The Furze

Design and Access statement - Addendum)

Provision of Adult Audiology
Haematology, Education
Centre and Clinical Admin Offices at
The Furze

THHFP1-LDW-XX-XX-RP-A-10001

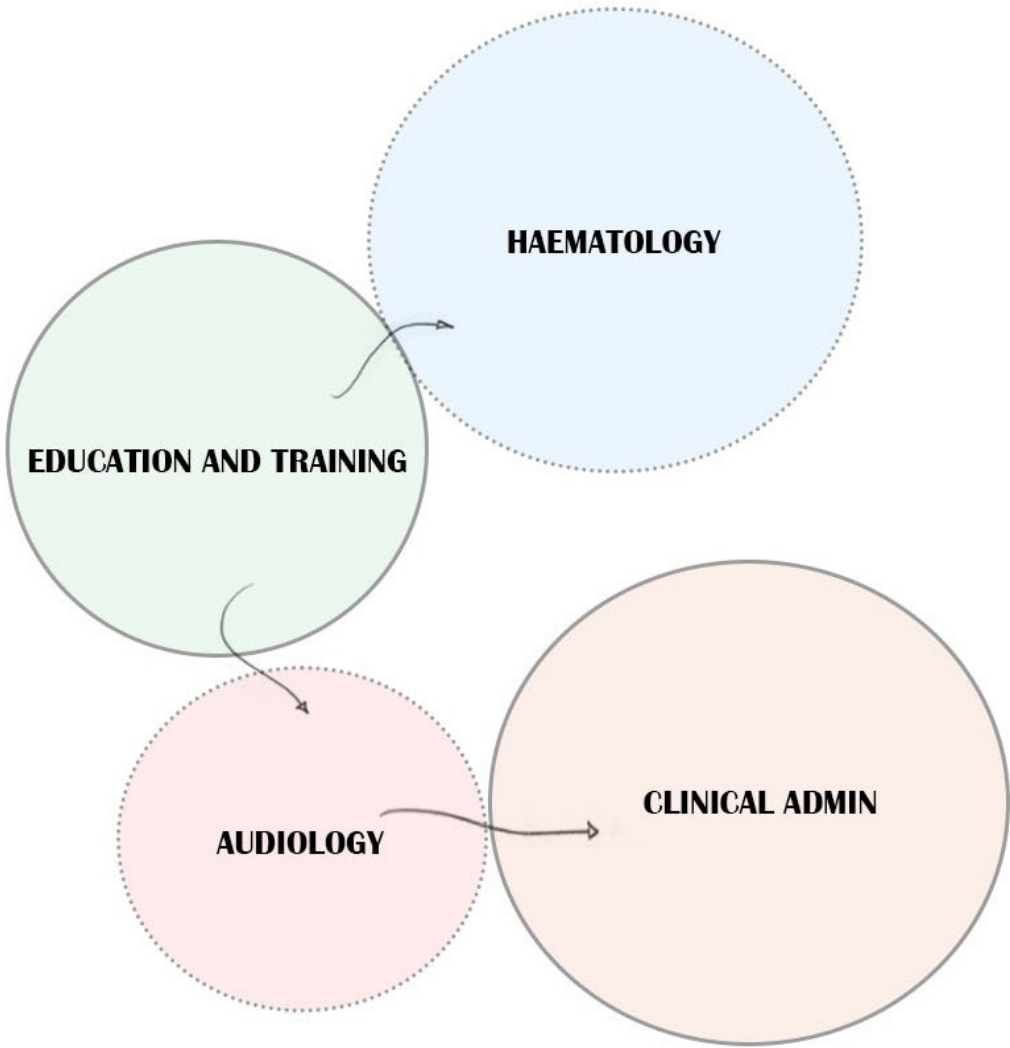
Following the conservation officers review, the Furze building new layout been revised to respond to the feedback regarding the level of intervention to the principal rooms. The new layout has resulted in the change to the audiology department internally, however this is within the 20th century extension.

The original early-19th century country house includes the clinical admin department on both floors (ground and first floor), the nature of this department is mainly office spaces which removes the addition of the partitions within the principal rooms.

The new proposal for the original part of the building be will be remedial work, with all original/ existing features are to be retained unless they are specifically marked otherwise on the drawings.

The Audiology department would be located within the existing paediatric audiology department, this space will require upgrading to comply with infection control.

3 Proposal - Ground Floor

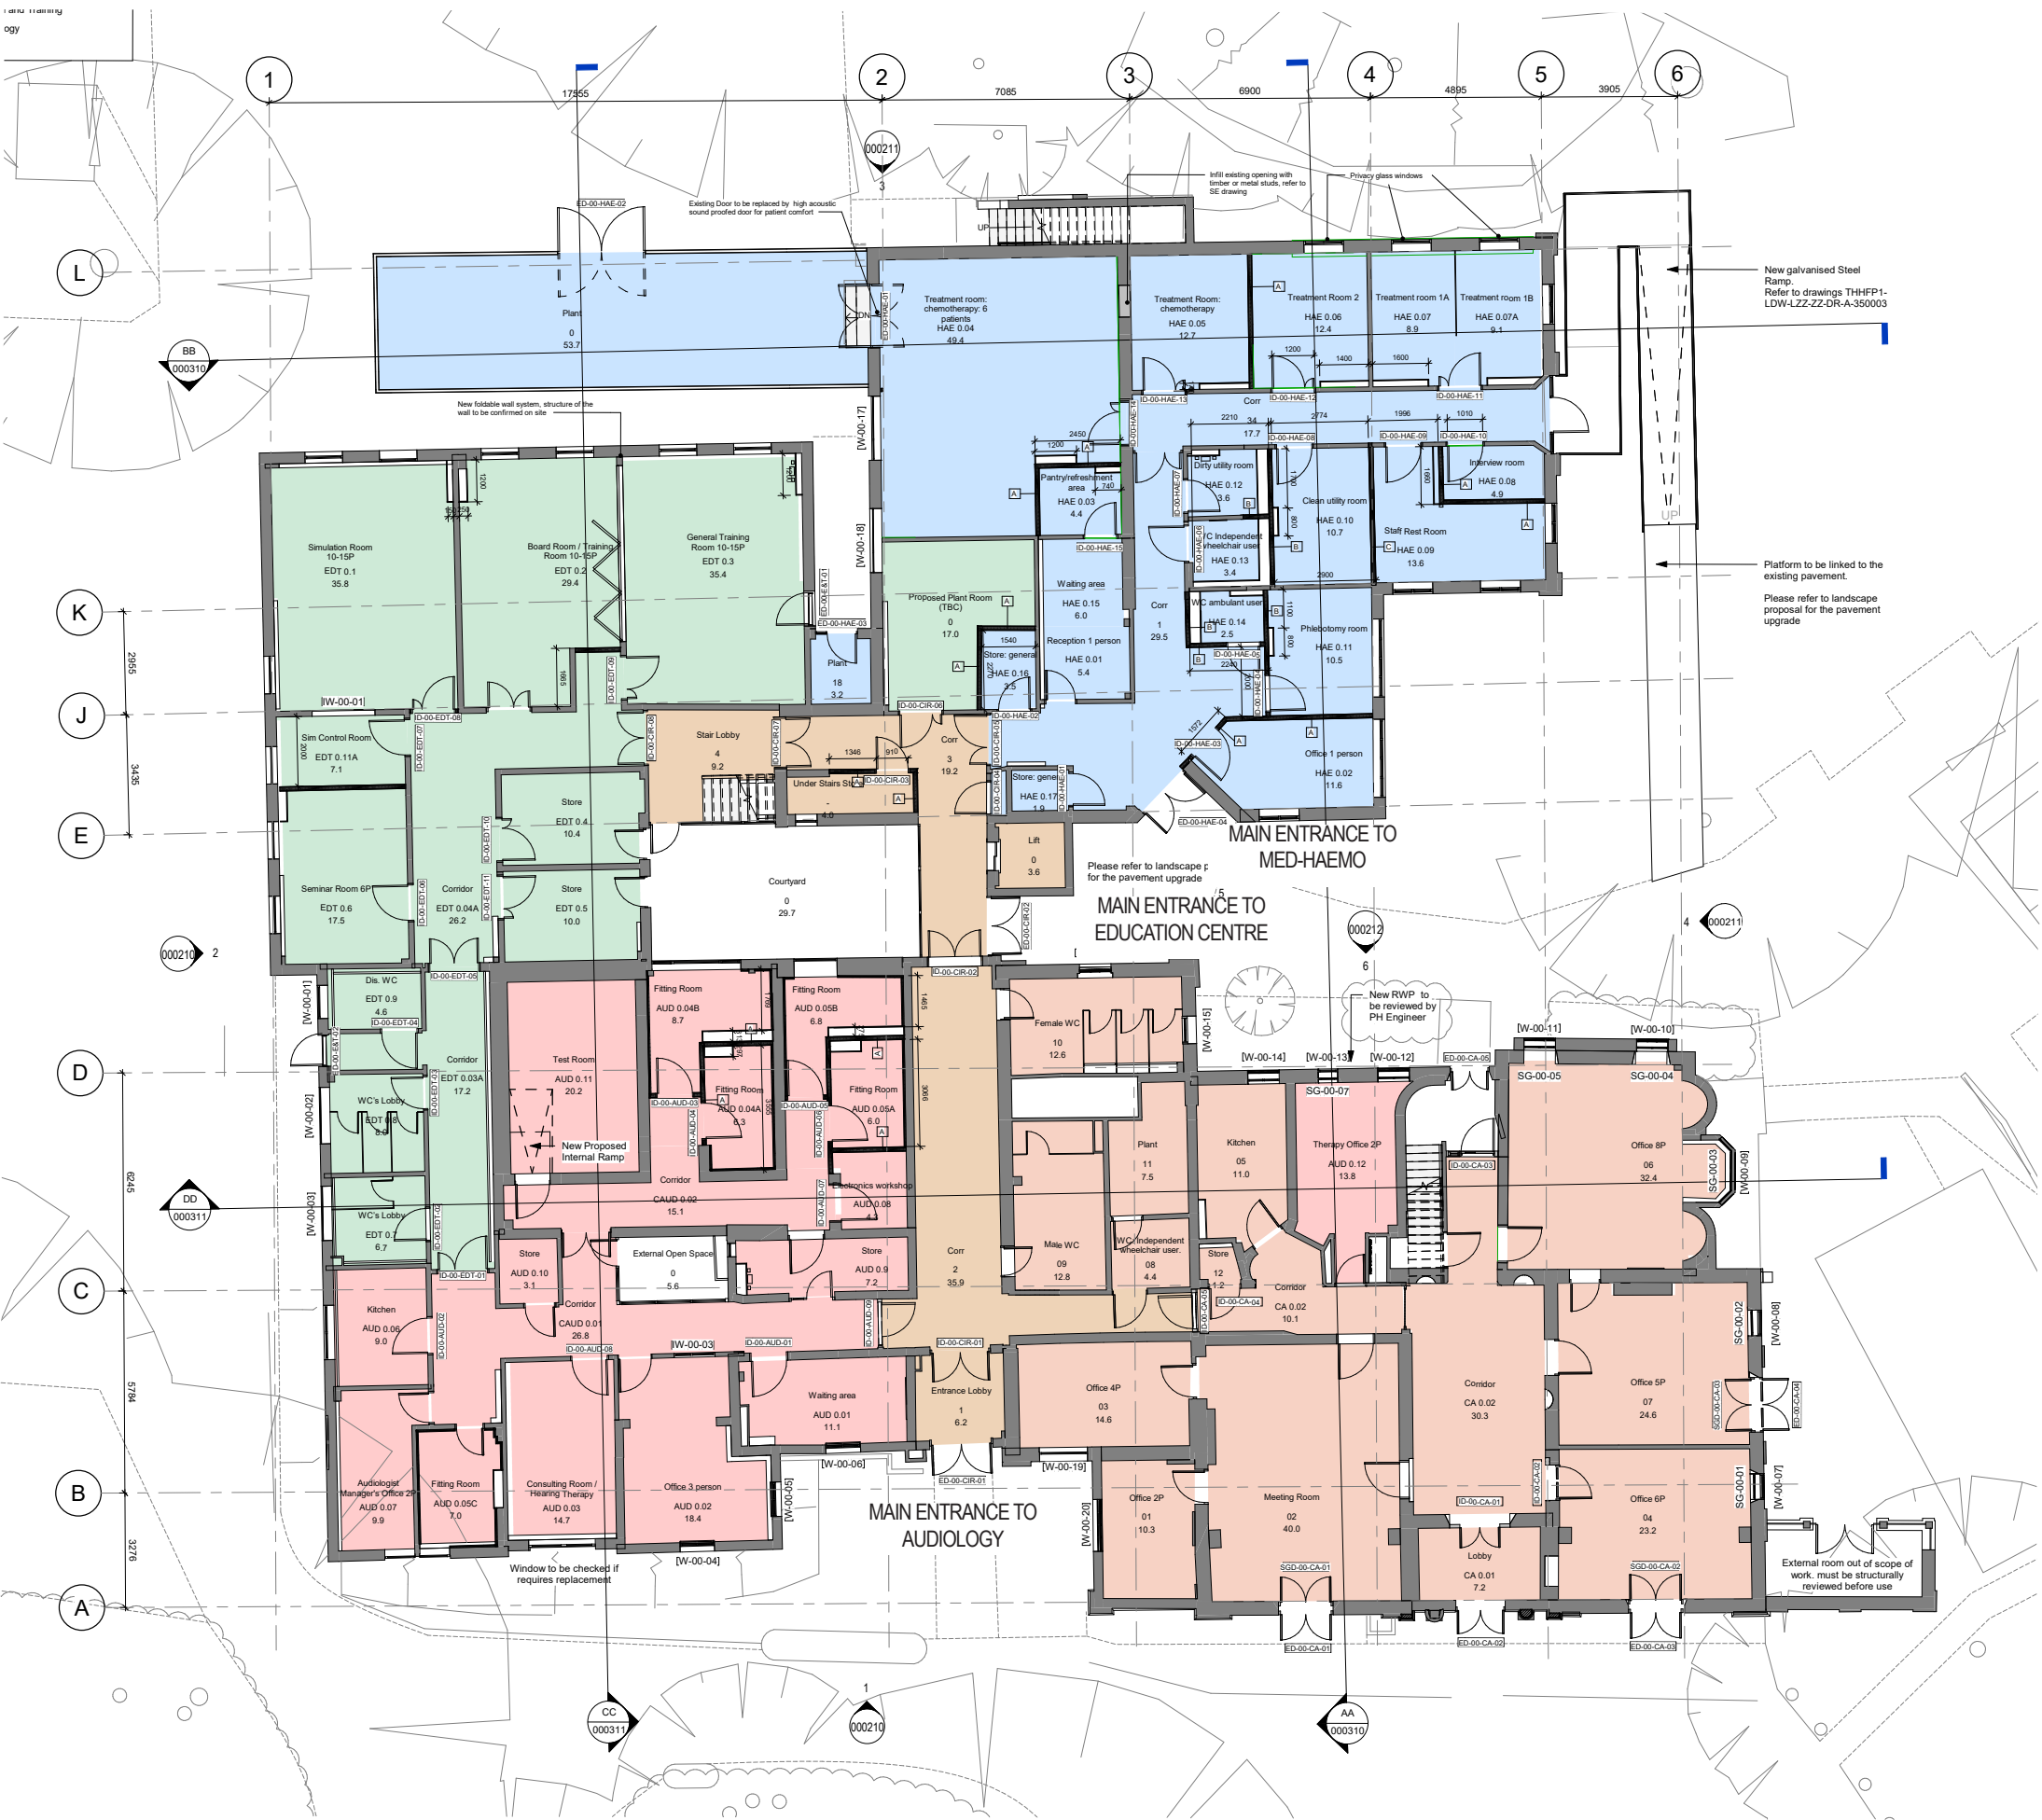
Haematology on Ground Floor and a new A/C unit will be covered by timber screen to suit the surrounding areas.

Adult Audiology on Ground Floor.

The layout is based on retaining as many existing room layouts.

Existing entrances have been retained.

3 Proposal - First and Second Floor

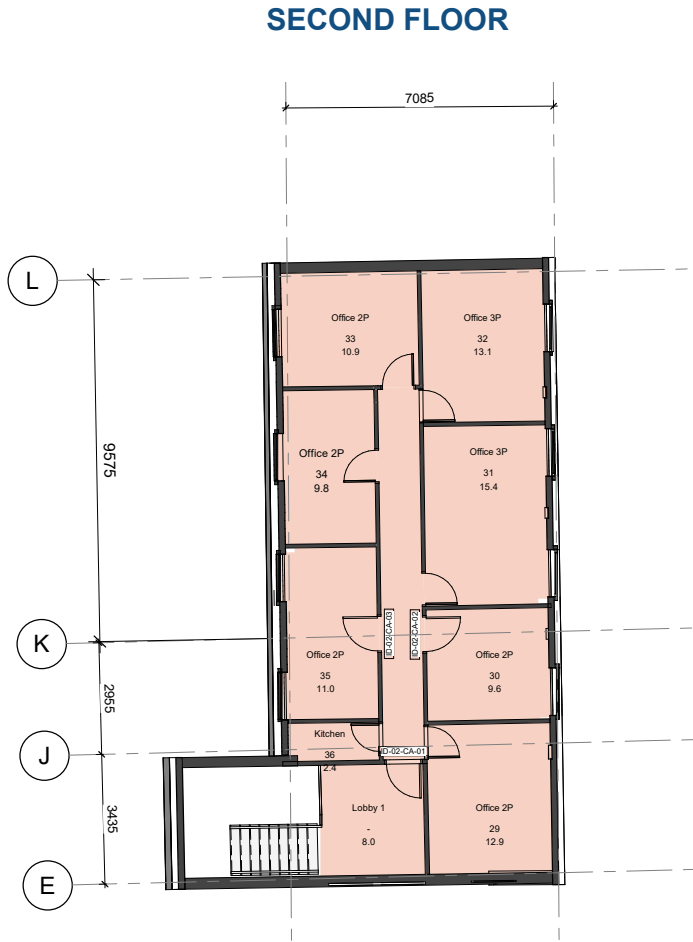
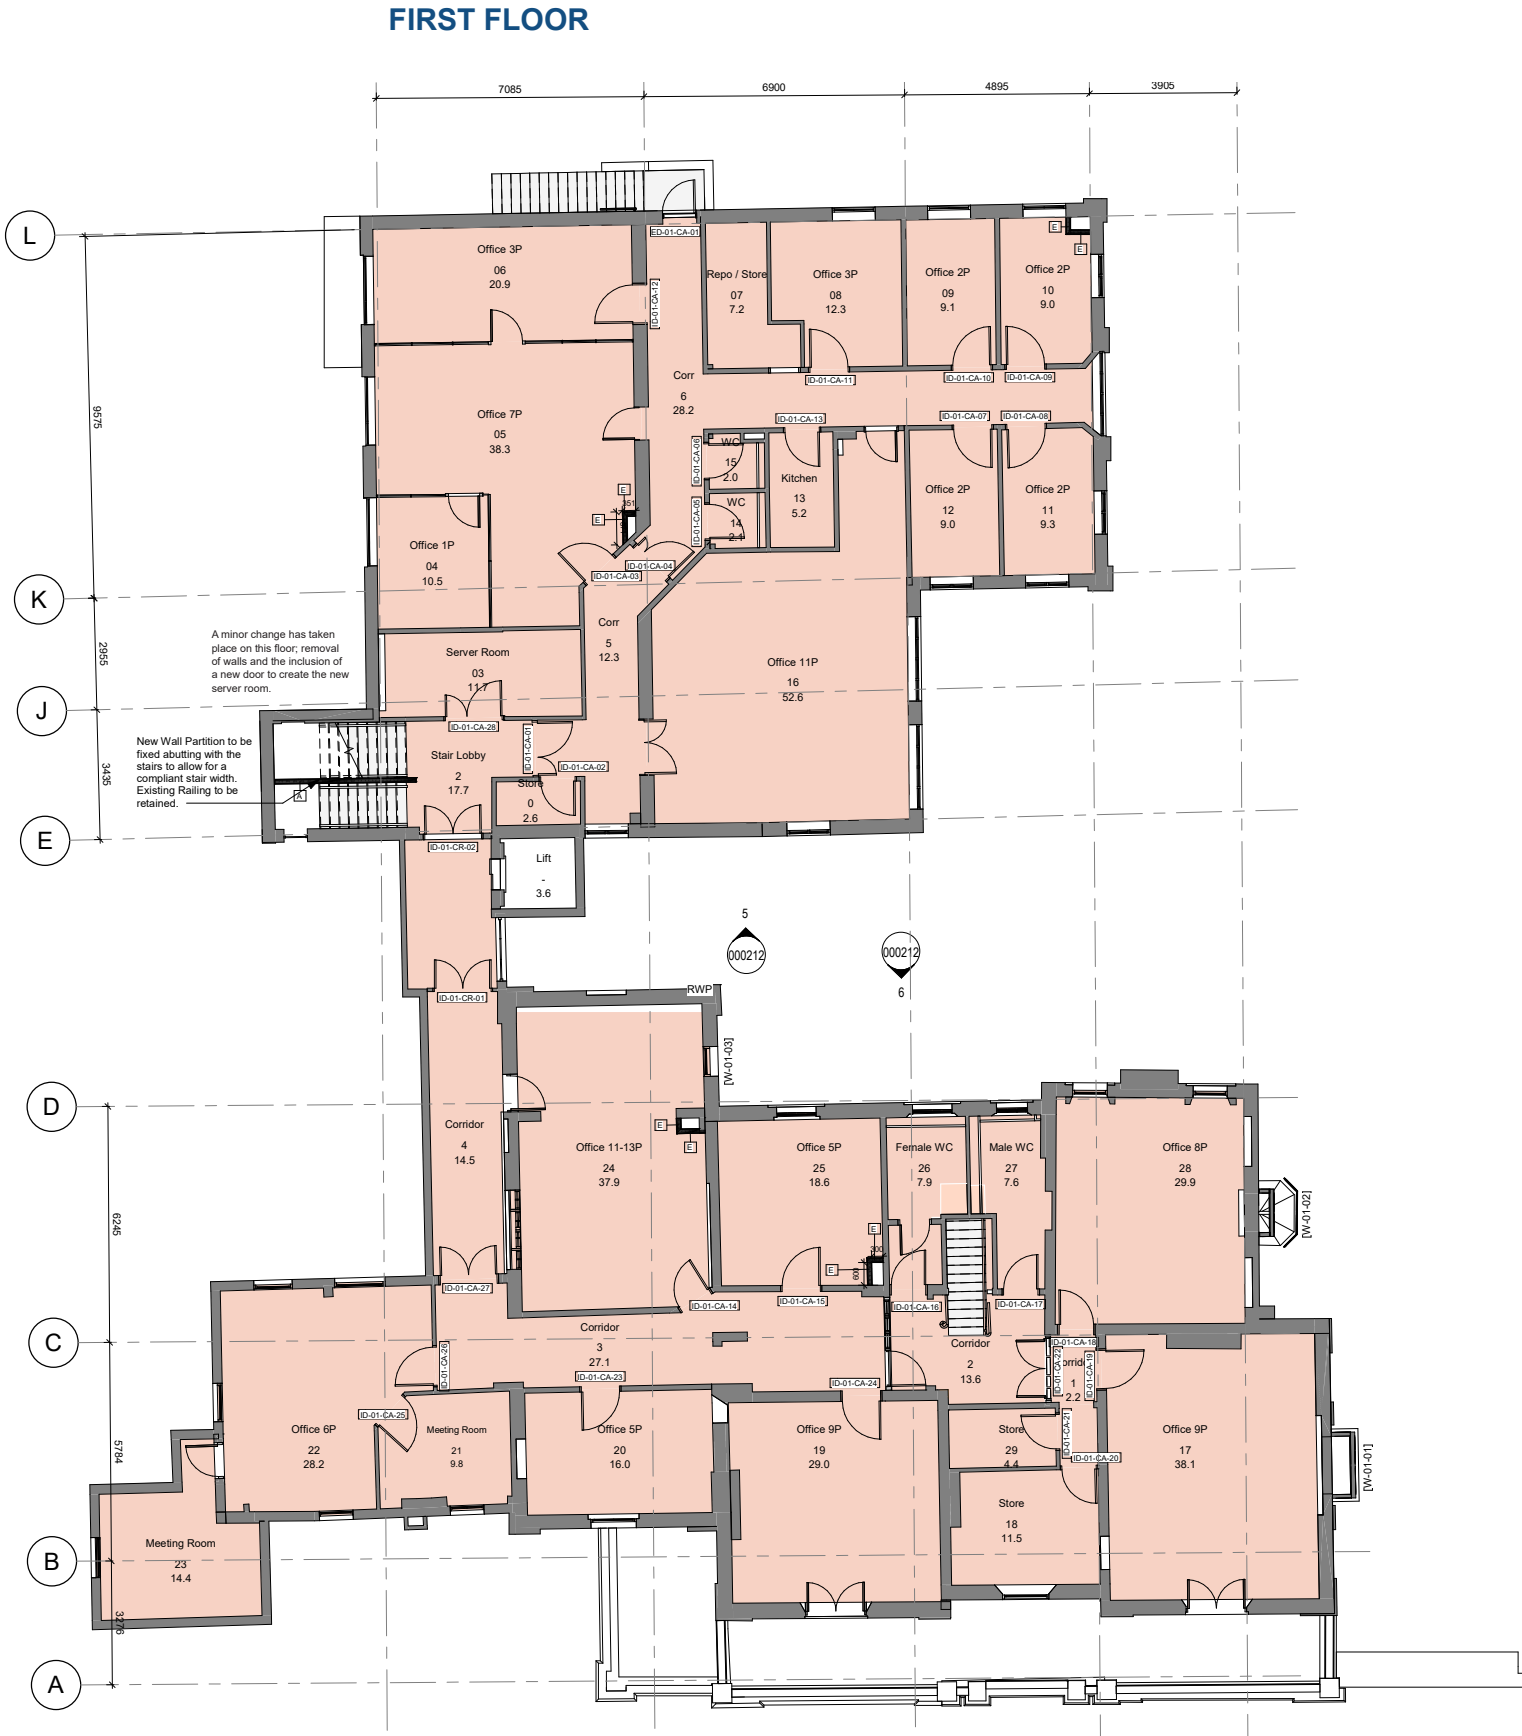
The first-floor layout has been retained with minimum removal of one door and one partition to allow for larger spaces. It has been assigned to the Admin offices, with no alterations or demolition to the existing layout.

3.2 Proposed Elevations

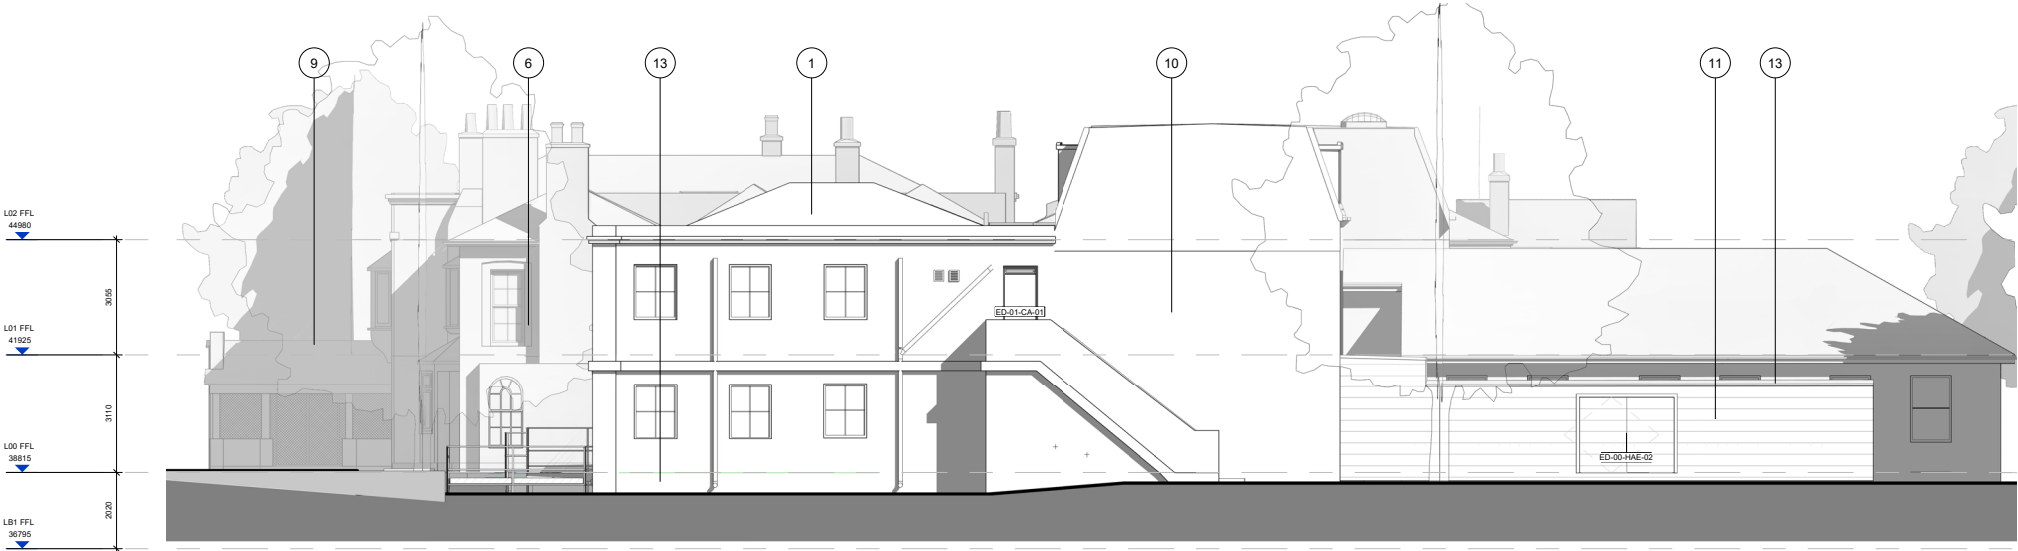
1. Existing roof to be retained and refurbished or replaced like for like where repair is not possible, including flashing and gutters. (Refer to roof survey for additional information)

2. The chimney brick to be repointed to match existing and all flashing to be made good.
3. Existing round roof light above 3 storey stairwell to be made good and replaced like for like if required.

4. All existing guttering to be made good and replaced like for like.
5. New render finish to replace existing decaying painted brick walls painted to match colour of Georgian stucco finish.

6. New timber fence enclosure to A/C Plant to be positioned in front of existing facade.
7. Existing windows & doors to be repaired or replaced like for like.

8. Existing decaying timber spandrel panels to be carefully removed to allow fire stopping to be made good.
New rendered rain screen panels to be installed in lieu of the removed timber

10. New Ventilation Grill locations
11. Roof covering to be added to the plant area for compliance with HTM 03-01 document, (When refurbishing or changing the use of an existing building, plant space should be created to house the ventilation plant and other services. If located at ground level they should be secured within a plant room to prevent unauthorised access.)

4 Plant Area.

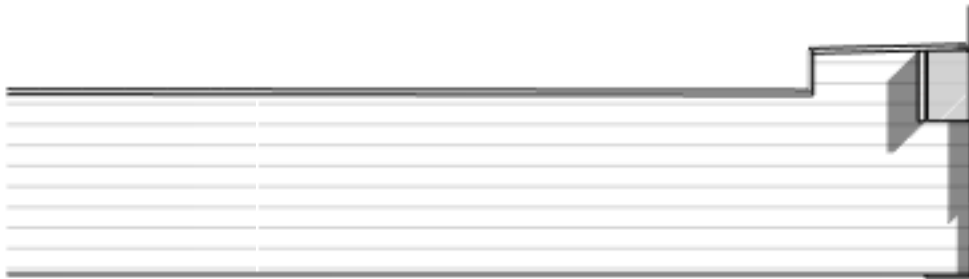
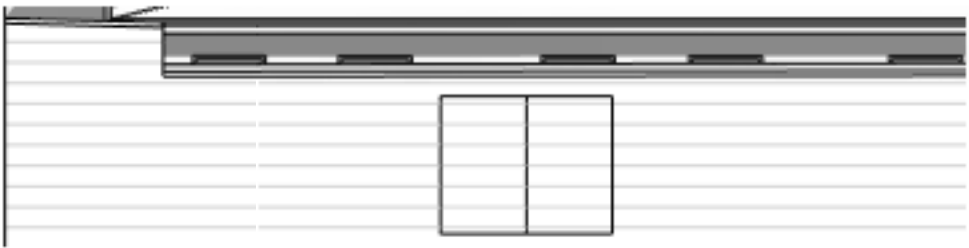
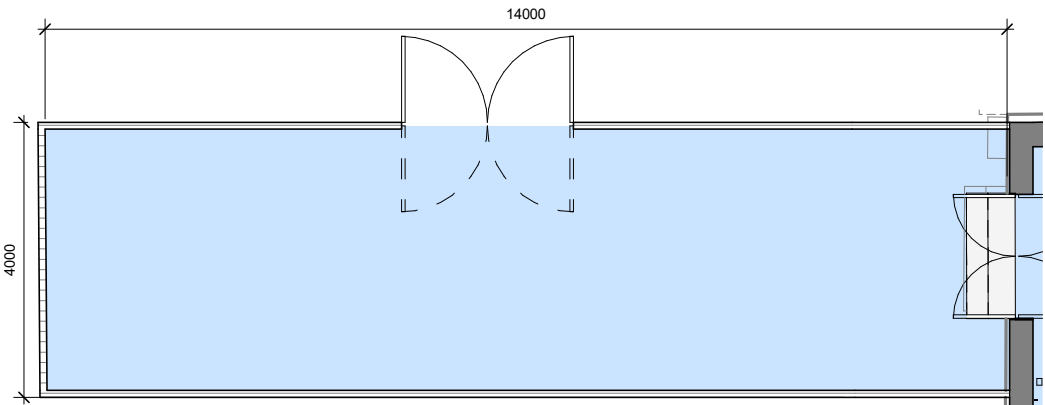
The Plant area roof

Following a recent update to the NHS Healthcare Technical Memorandum 03-01 document (HTM 03-01 Specialised ventilation for healthcare buildings), which sets out the legal requirements for ventilation and plant room requirements for healthcare buildings, an enclosed roof is now proposed for the rear plant area to comply with NHS regulations.

The HTM document states the following (when refurbishing or changing the use of an existing building, plant space should be created to house the ventilation plant and other services. If located at ground level they should be secured within an enclosed plant room to prevent unauthorised access).

The proposed roof of the plant room is designed to match the simple timber cladding material of the walls.
